| Charlotte Historic Distric Staff Review HDC 2015-290 | t Commission | Application for a Certificate of Appropriateness Date: January 13, 2015 PID# 12108304 |
| PROPERTY ADDRESS: | 715 East Worthington Avenue | |
| SUMMARY OF REQUEST: | Plan revision for approved addition (October 14, 2015) | |

Revised Plan Summary

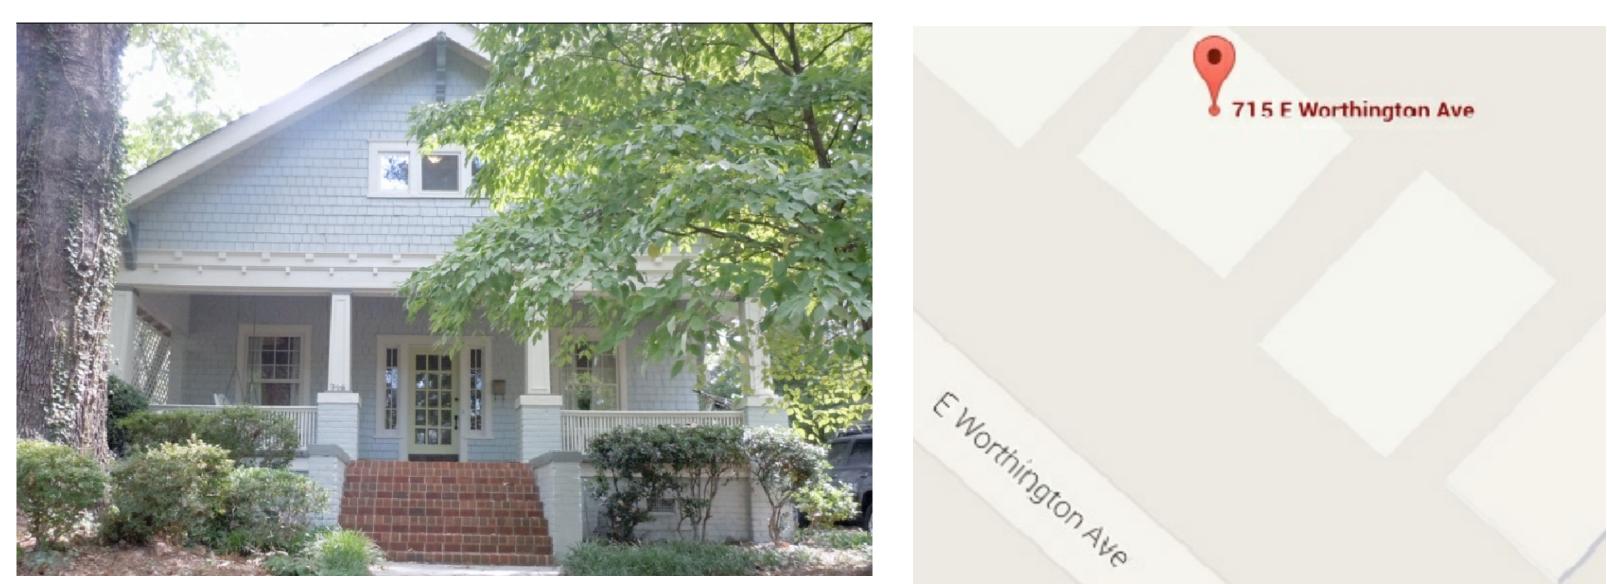
- 1. Removal of new chimney on right side
- 2. Extension of dormers on the left and right elevations
- 3. Removal of rear screened porch
